AT-1200 RED LED Soundhead Field Service Bulletin

Dolby Laboratories Inc.
Field Bulletin 218

Reverse Scan Analog Soundhead Readers
Extending LED Life
Solar cell preamp gain change and LED drive current change

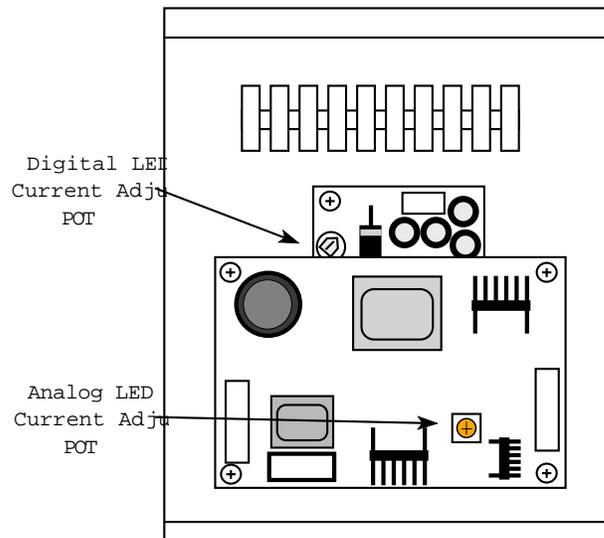
- Remove wire jumpers J3 and J4 on the PC#7929 solar cell preamp board.
- Reduce the power supply current driving the LED while maintaining enough LED illumination to achieve Dolby Level.

1. Use wire cutters to carefully remove jumper wires J3 and J4 on the PC# 7929 solar cell board. See the figure below showing jumper locations.
